HASAN TANVIR FASHION WEARS LTD. (EXTENSION)

16 March 2025

2. Observations:

Observation-3: Poorly connected cable bracings on the wall. (Finished Goods Store)

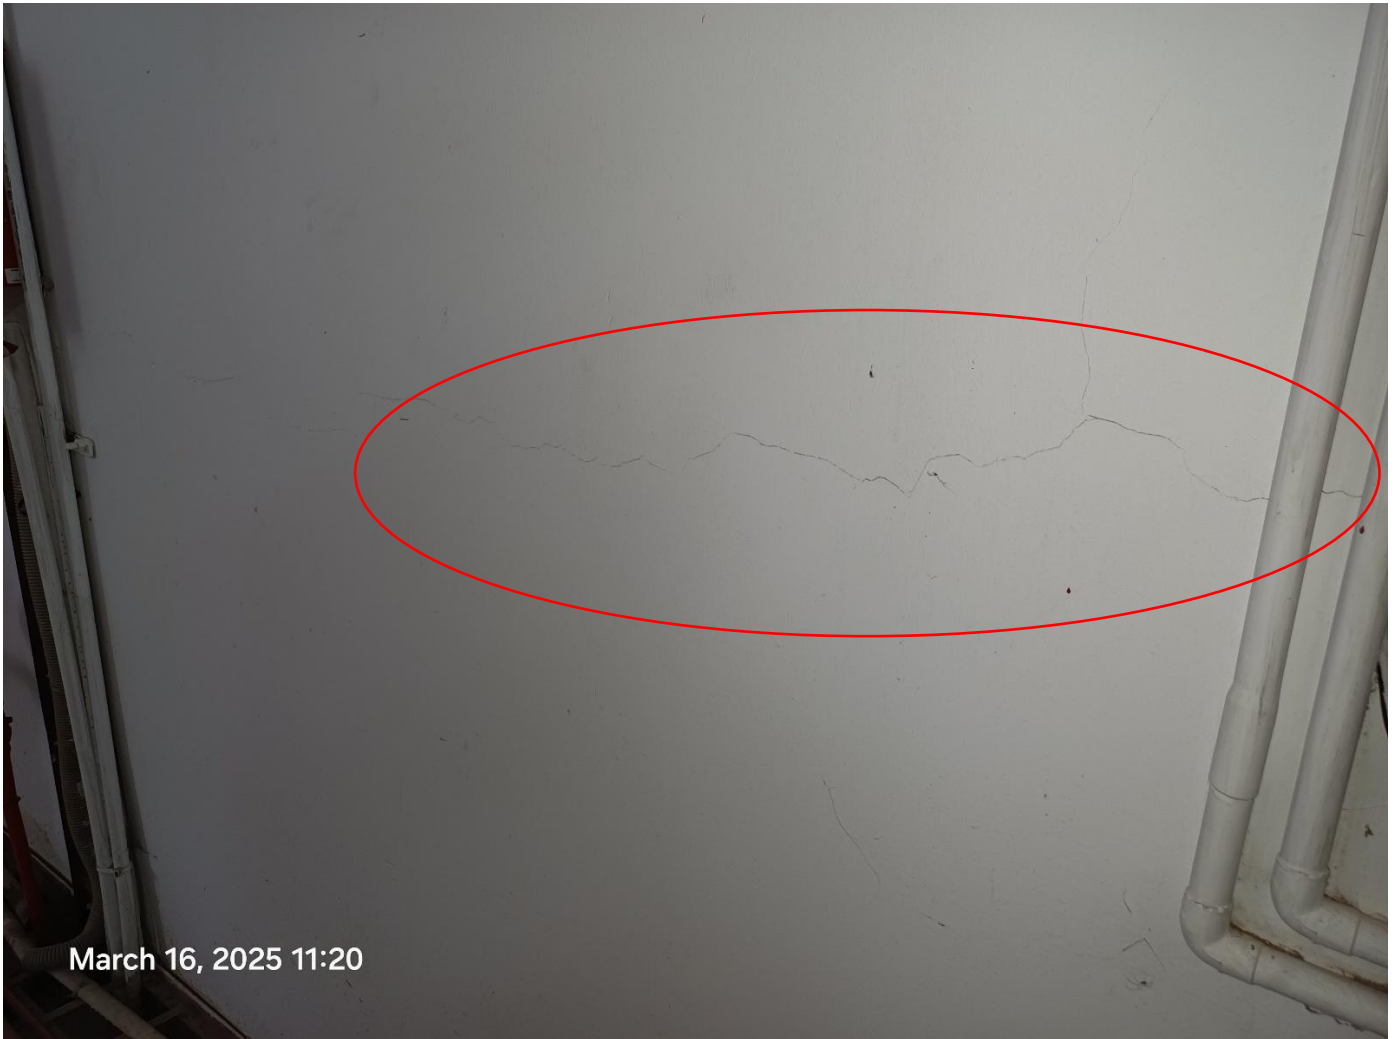
Description: During the inspection, poorly connected cable bracings were found on the northside wall. Building engineer is required to install the bracings properly.
